1100 NW 54TH ST

3033727 // EDG 2 // NORTHWEST DESIGN REVIEW BOARD
21 October 2019

Park Fabric EDG1 view

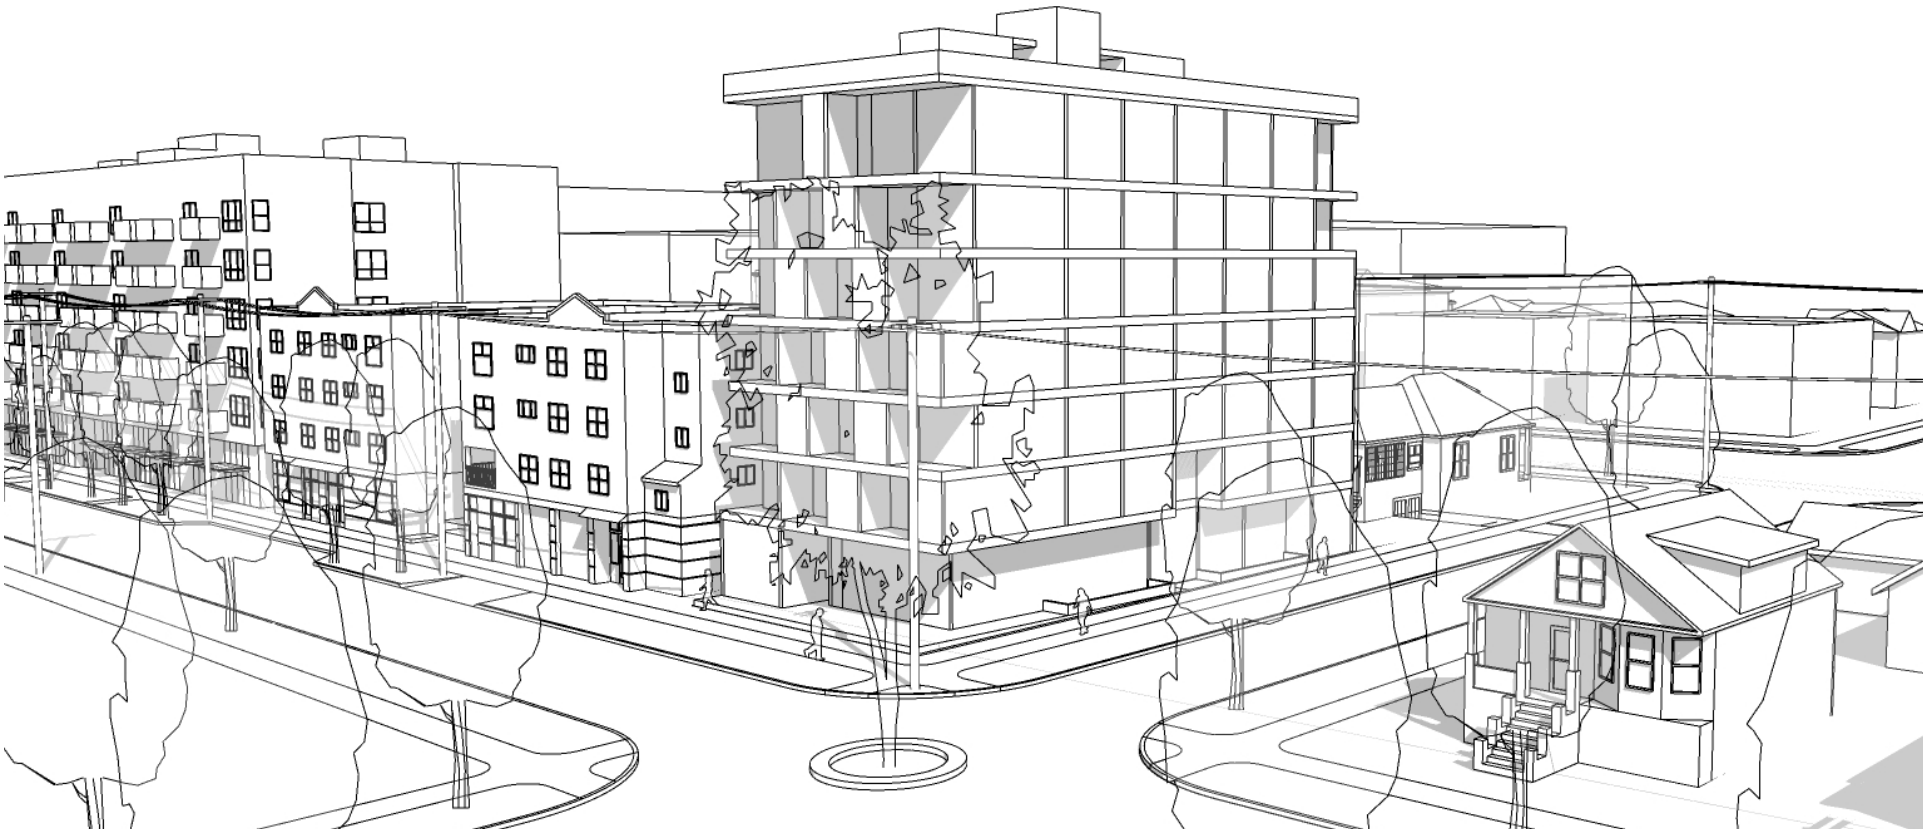
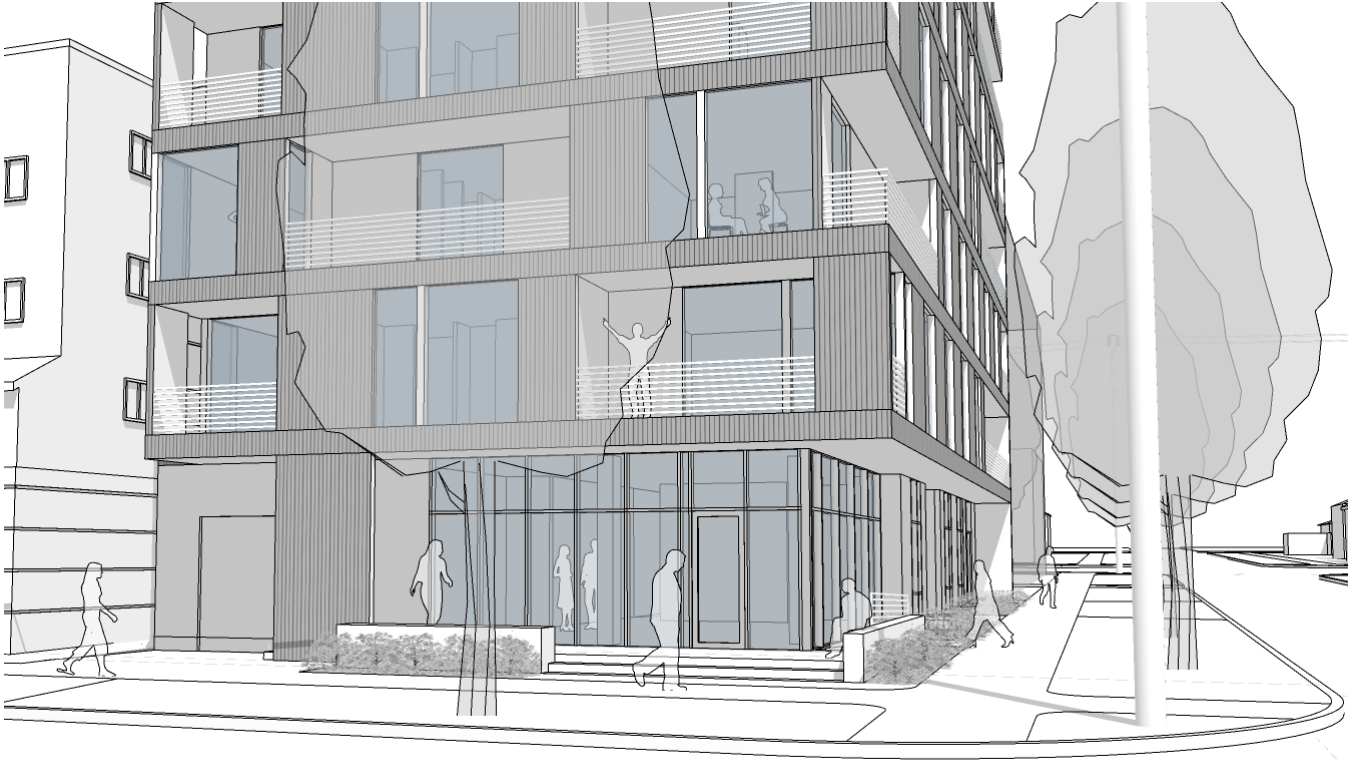
i. The Board voiced strong support for the design concept of Scheme C (Park Fabric) illustrating the usage of loggias primarily applied to the design’s south façade with minor application of the loggias to the upper-levels of the massing’s north façade; and agreed that this architectural parti is an opportunity to provide connectivity to the existing park across from the project site. (CS2.B, CS2.C.1)

ii. The Board emphasized that the future massing should provide an appropriate transition to the Lowrise-zoned (LR3) properties east of the project site and the lower-intensity neighborhood commercial zoning (NC2-55) to the north. The Board articulated that Scheme C was the strongest design concept but the Board was very concerned with the height, bulk and scale of the massing form on 11th Avenue Northwest and its impact to the lower-scaled properties to the east. Thus, the Board directed the design team to address this concern in the next design iteration presented at the next EDG meeting. A design that illustrates an application of the loggia concept to the entire massing on both street facades wrapping to the upper-levels of the north façade would be considered a strong response to this guidance. (CS2.D)

Response: Park Fabric has been further developed by distributing loggia on the south and east facades, along with the upper levels of the north facade. The concept scales the facade providing depth and activation to appropriately transition to the lower intensity zones. The design team studied the east side, particularly the northeast corner, and sculpted an alternating pattern of loggia into the facade. While the massing is substantially carved away along faces and at corners it maintains a primary cohesive form.

Park Fabric shell & liner

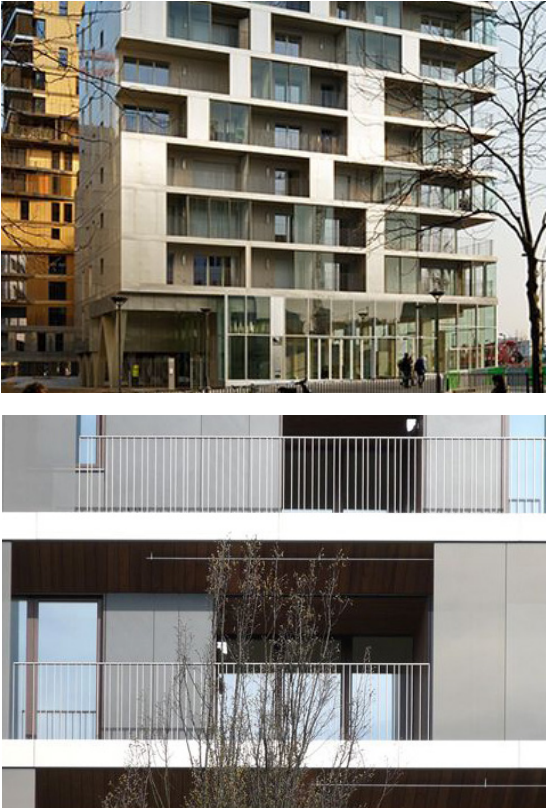
iii. The Board compared the design development image to the precedent images provided in the design packet (pg. 42) and questioned how the loggias would be perceived. The Board requested that the loggia design concept be pushed further to demonstrate that the perceived erosion and reduction of massing will be achieved within this concept. The Board encouraged study of the proposed materiality of the loggia concept and requested that more detail be provided at the next EDG meeting. (DC2.A, DC2.B, DC2.C)

Response: The primary form is conceived as a “shell” clad in a neutral toned high quality material. Where the mass has been eroded for loggia a wall and soffit “liner” material, along with transparent guardrails, will be used to high-light the volumetric reduction. A contrasting yet complimentary application of material will be used to scale all four facades as an integrated system.

Park Fabric north side

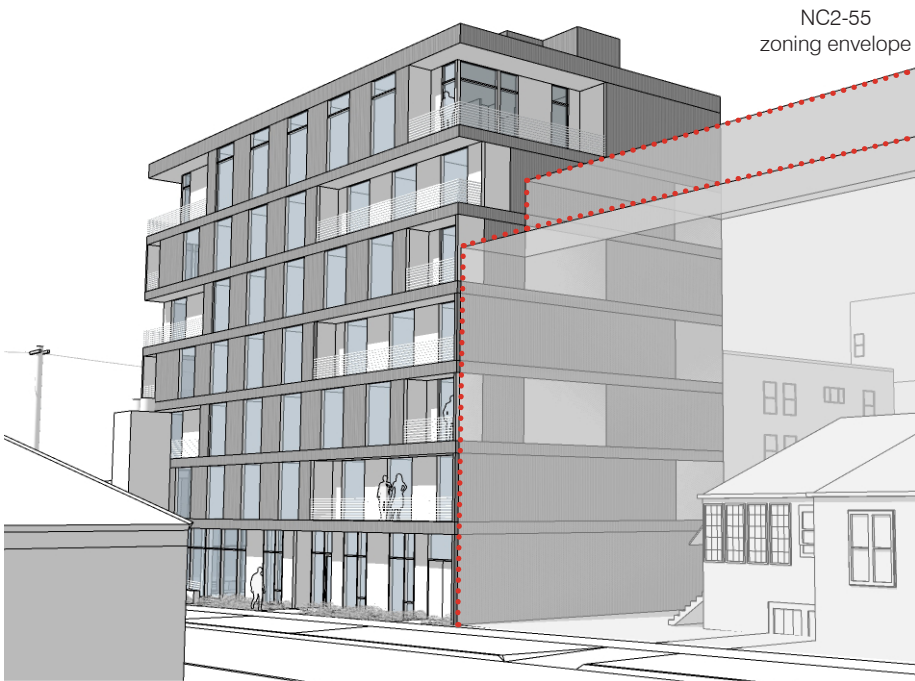
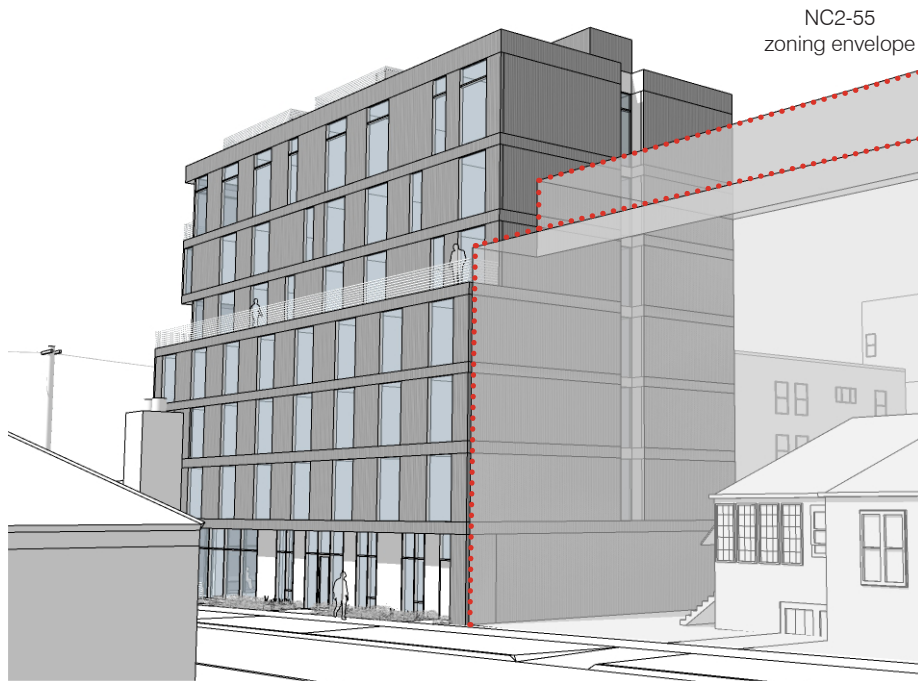
b. The Board discussed the treatment of the north façade which is a party wall. In reviewing the massing diagrams in the EDG design packet, the Board recognized that the visibility of a majority of this façade would be a temporary condition until future development occurs at the adjacent property north of the subject site (pg. 24). However, the Board also acknowledged that a portion of the upper-stories of the north façade would be permanently visible and stated that further study of the treatment of this portion of the facade is necessary as the building evolves. (DC2.A, DC2.B, DC2.C, DC2.D)

Response: The preferred option, Park Fabric, carves out the corner of level 6 and 7 continuing the loggia vocabulary onto the portions of the facade that will remain exposed above the future NC2-55 development. The remainder of the blank wall will utilize a siding pattern that corresponds to the graphic contrast of the shell & liner concept. This language is also carried around to the west facade. One Step utilizes a central corridor reveal to scale the north facade.

Park Fabric west elevation

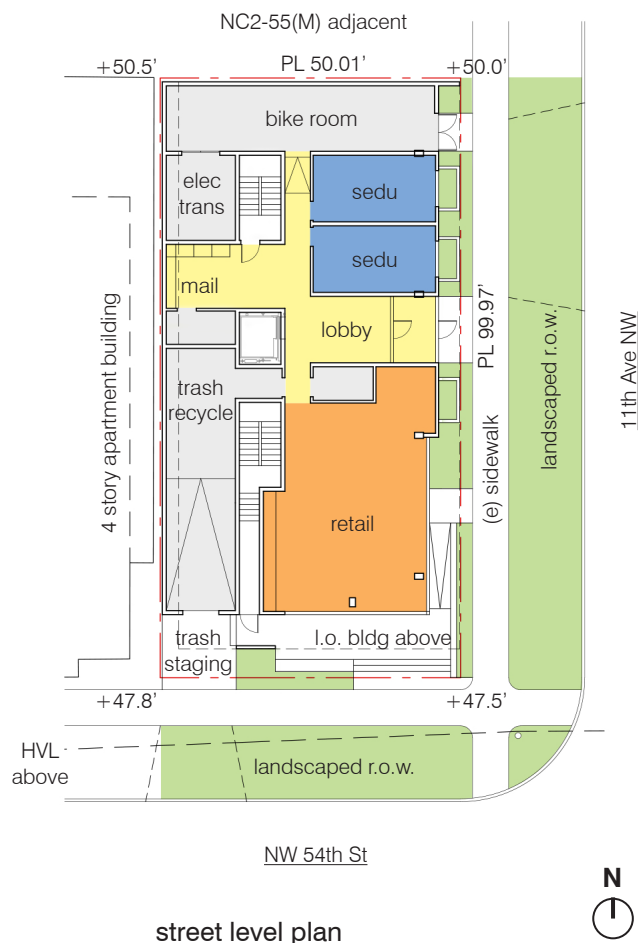
c. The Board requested that the applicant provide a window study at the next meeting to clarify how the future massing would minimize disrupting the privacy of the residents in the adjacent building west of the project site. (CS2.D.5)

Response: A window study showing the neighbor to the west is included. With the organization of compact units along the west edge, alignment of windows has been considered and minimal overlap is achieved.

Park Fabric pedestrian environment south edge

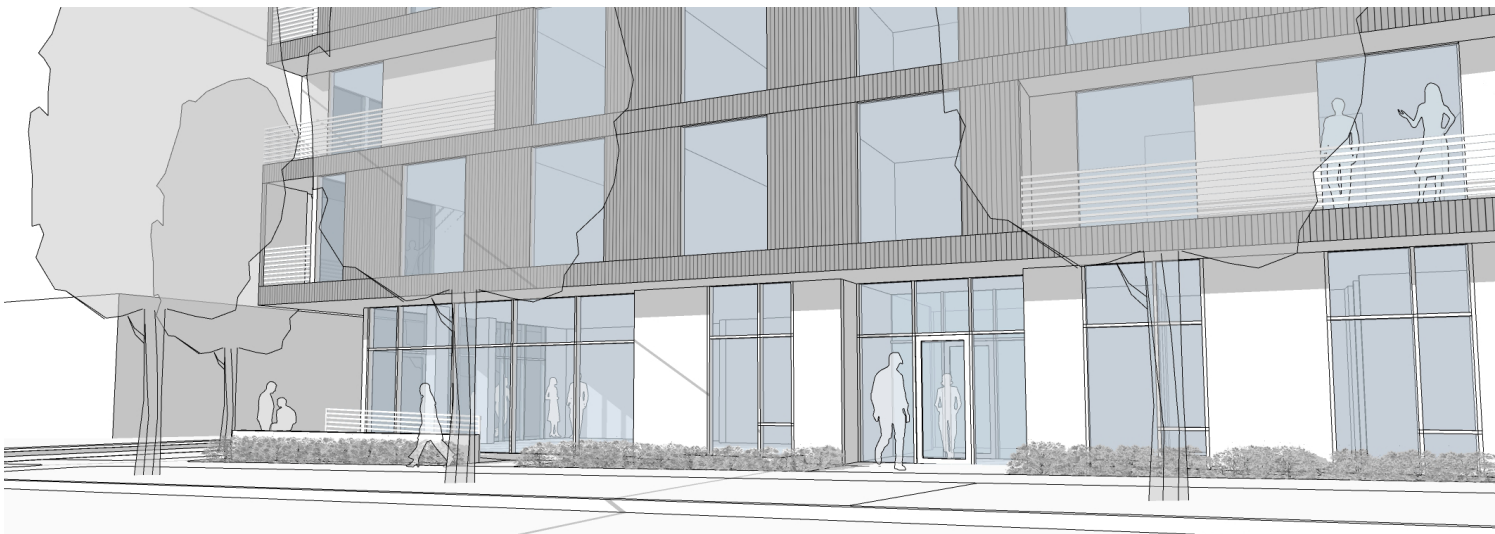
- c. The Board appreciated the separation of service uses (waste storage and bike storage rooms) and their respective entries located at alternative street-facing facades. However, the Board voiced concern that the massing of these storage areas are too prominent on the streetscape due to their location proud of the entire recessed street-level façade. The Board stated that these building protrusions needed to integrate better with the overall elevation (recessed) and the streetscape; and stated that this Board concern should be addressed in the next design iteration. (DC1.A, DC1.B, DC1.C.4, DC2.A)

Response: The separation of service uses has been maintained. The street facing facades have been pulled back to integrate into the plane of the adjacent facades creating a continuous setback and soffit around the south and east sides of the project. A six foot wide wall conceals the exit door, integrates with the broader architectural system of opening and wall plane above, and helps to separate the southwest corner services from the semi-public terrace. SPU will not service dumpsters from inside the building, so the setback in the southwest corner allows for dumpster staging between the building and sidewalk.

east edge detail

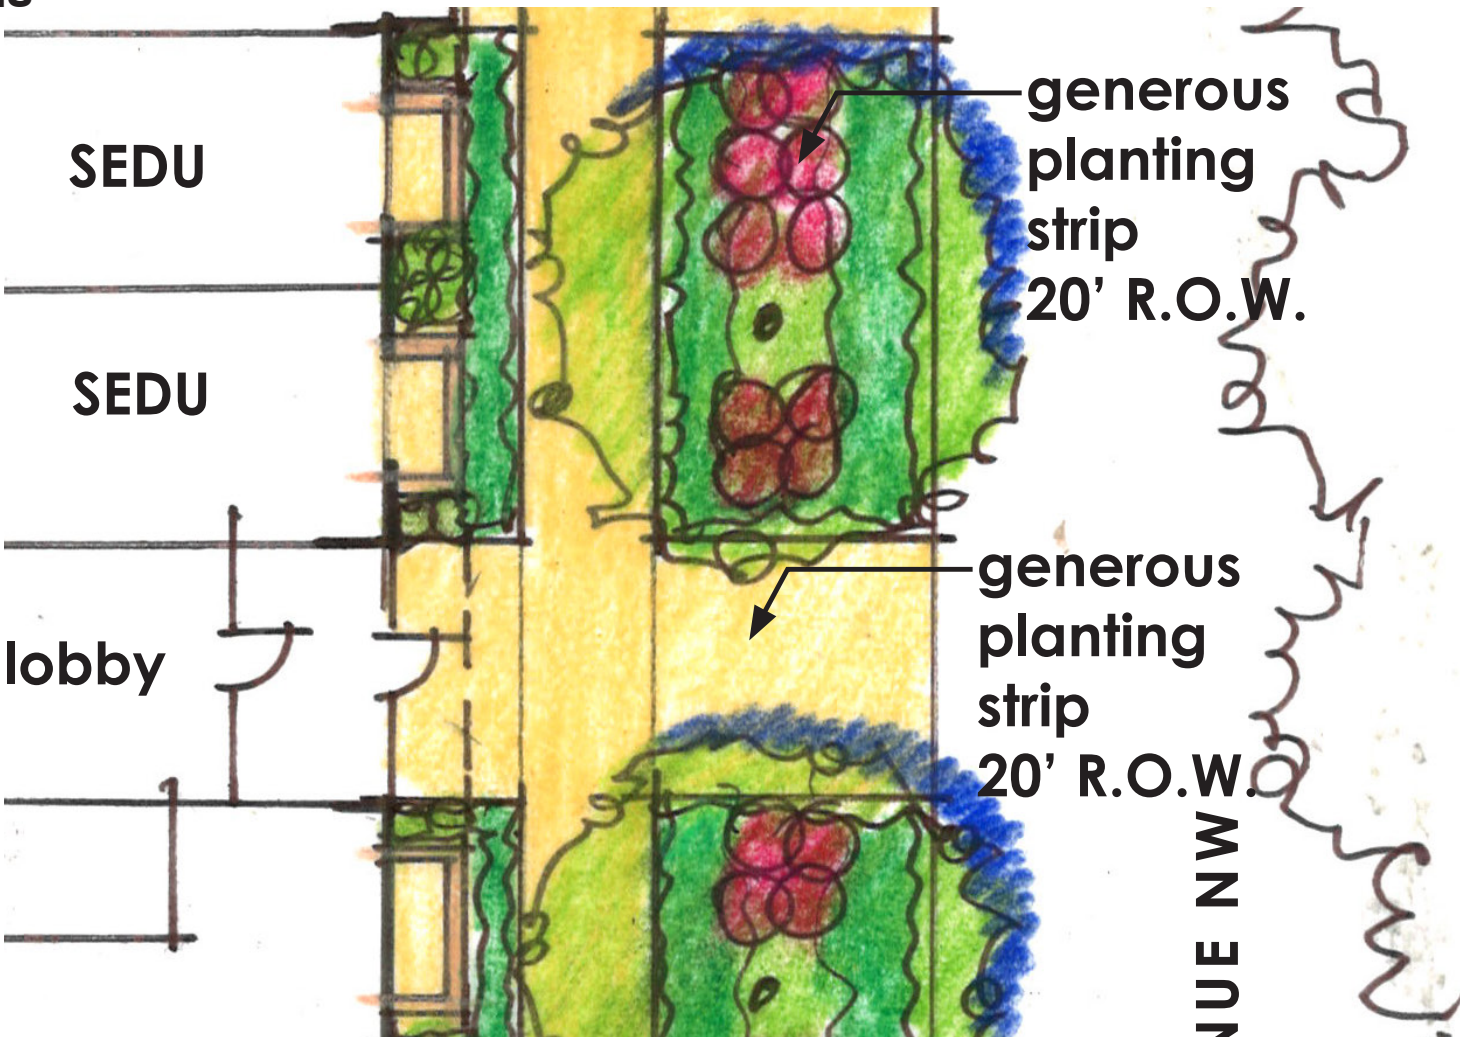
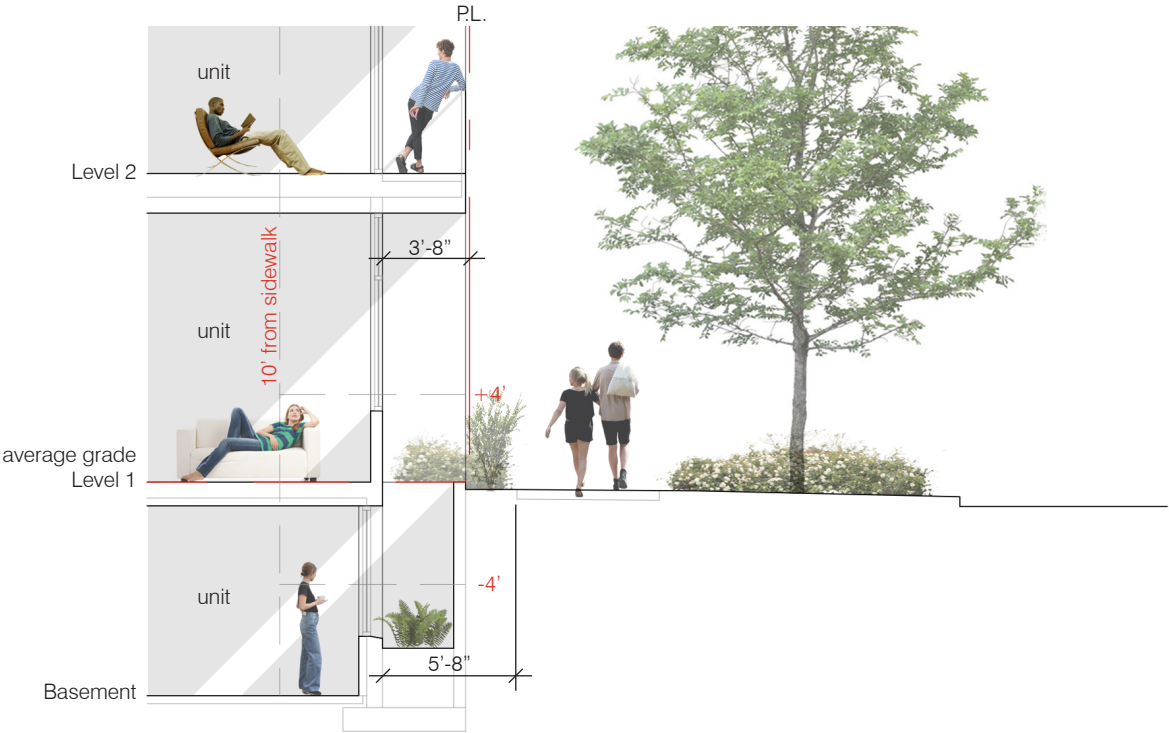
d. The Board voiced concerns about the livability of the basement small efficiency dwelling units (SEDUs) (specifically future residents' access to light and air) and the possible impacts of the associated light wells to the onsite landscaped buffer and 11th Avenue Northwest streetscape. The Board encouraged further study of these basement SEDUs, exploring methods (changes to internal configuration, etc.) that fundamentally enhance the residential experience and mitigate the impact of the light wells to the streetscape. The Board agreed that this feedback is connected with Board direction regarding street-level departures and requested that building sections be provided at the next EDG meeting. (PL3.B, DC3.A, See Departure #2)

Response: Rather than a large continuous light well edge as presented at EDG1, the wells have been designed to scale to each of the three basement SEDU units. This increases the potential for on-grade landscaping between the sidewalk and the building edge and creates a rhythm of ground elements that correspond to the window openings and broader architectural concept of loggia distribution. Each 220 sqft basement unit will receive a 32 sqft window with large operable casement section for access to light and air. With a 3'x6.5' footprint each well acts as an intimate private garden for dwelling residents. Compared to EDG1 the well width has been extended from 30" to 36" and the height of the concrete walls will be kept to the minimum required to retain the adjacent planting strip and existing sidewalk grade. As the wells are two feet off the adjacent sidewalk building code may require an open guardrail or metal grating lid for pedestrian safety and security.
